WEST OF IFIELD PHASE 1B

Stage 1 Road Safety Audit

10051123-ARC-XXX-1B-TR-HE-00002

DECEMBER 2024

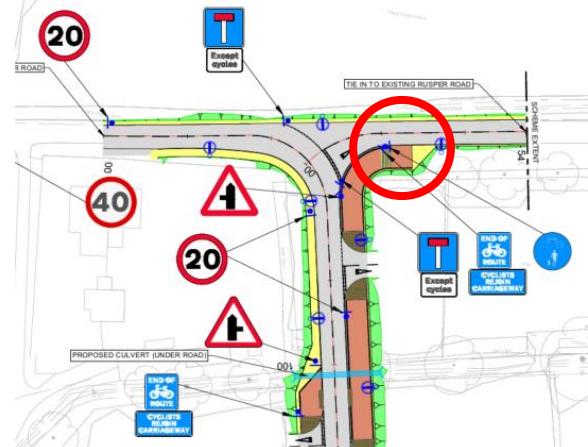
Location: C – Phase 1B alignment, northern and southern section of scheme (Drg. 10051123_ARC-010-1B-DR-HE-00001 Rev P04 and Drg. 10051123_ARC-010-1B-DR-HE-00007 Rev P04)

Summary: Risk of head-on collisions between cyclists and motorists.

Whilst shared use facilities are provided generally along the scheme, there is a risk that some shared use terminal points may force walkers and cyclists to exit the facilities onto the verge, into opposing traffic lanes unaided or onto a narrower section of footpath (see insert showing southern section of scheme), putting themselves at risk of head-on collisions, being struck when crossing or continuing along unsuitably narrow sections of footpath.

A similar situation occurs at the northern tie-in of the scheme.

The Audit Team notes that design measures particularly at the tie-in points, may take account of adjacent developments that fall outside the scope of this audit.

It is recommended that shared use provision at terminal points is safe, clear, appropriately signed and supplemented with tactile paving. Furthermore, ensure that if permitted, cyclists are able to safely access / leave the shared use facilities at all access and terminal points.

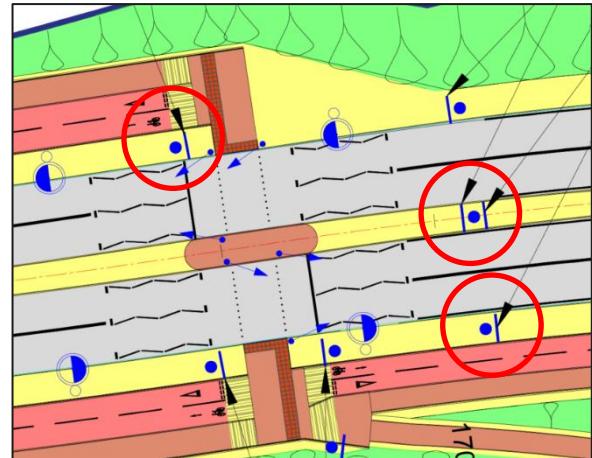
Location: H - Crawley Western Link Road CH1+690 (Drg. 10051123_ARC-XXX-1B-DR-HE-00001 Rev P04).

Summary: Risk of overshooting / late braking / crossing collisions.

There is a risk that the speed limit and shared use signs located in advance of the controlled pedestrian crossing facility may obscure the traffic signal operation (see insert). This may lead to overshooting / late braking / crossing collisions.

Ensure speed limit signs do not obscure the operation of the crossing traffic signals.

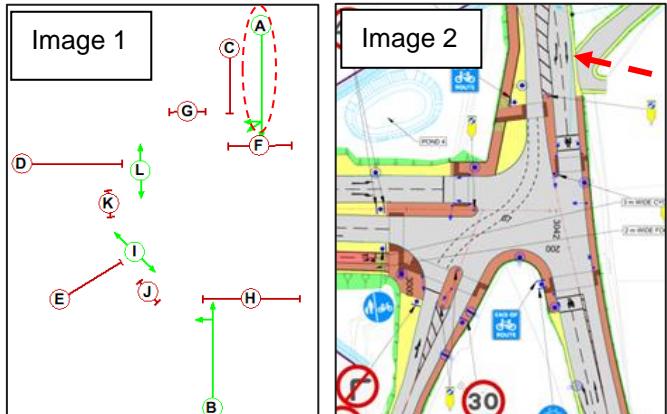
Location: I – Charlwood Road / Ifield Avenue, West of Ifield Phase 1B (Drg. 10051123_ARC-010-1B-DR-HE-00007 Rev P04)

Summary: Risk of turning traffic collisions.

Southbound 'nearside' traffic from Charlwood Road (Phase A - all movements) appears permitted to run 'opposed' with northbound nearside and offside traffic from Ifield Avenue (Phase B - all movements), whilst Phase C (Charlwood Road southbound left turn) is 'held' for traffic.

This arrangement may result in confusion and may lead to late braking or lane changing collisions, as northbound motorists travelling from Ifield Avenue are presented with right turning motorists not emerging from the opposing 'offside' lane of Charlwood Road (as this is phase currently held in Stage 1) but the 'nearside' lane.

The Audit Team notes that the 'nearside lane of Charlwood Road is proposed as ahead-only, and very little has been provided to manage or guide opposing traffic through the junction (see image 2).

This issue was raised in the previous Stage 1 Road Safety Audit report (Problem 1).

Location: I – Ifield Green / Ifield Avenue / Charlwood Road (Drg. 10051123_ARC-010-1B-DR-HE-00007 Rev P04)

Summary: Risk of loss of control collisions.

Northbound motorists approaching the Ifield Green / Ifield Avenue / Charlwood Road junction will emerge from Ifield Green and immediately be presented with an offset junction alignment (see insert). This alignment, which may or may not be clear to approaching motorists travelling along the 40mph road, may result in loss of control collisions. This situation could be worse particularly during the hours of darkness, poor weather conditions or because of excessive speed.

Although guidance markings appear to be provided to highlight the alignment, they are likely to be ineffective during wet weather periods, or quickly eroded through junction turning traffic manoeuvres.

Ensure that the operation of the junction promotes safe turning traffic manoeuvres with good vehicle positioning, and that carriageway markings are not confusing.

Provide advance warning of the traffic signal junction ahead. In addition, there may also be benefit in providing a map-type sign on the approach to the junction, similar to those provided on all other approaches. The use of speed management measures may also benefit safety.
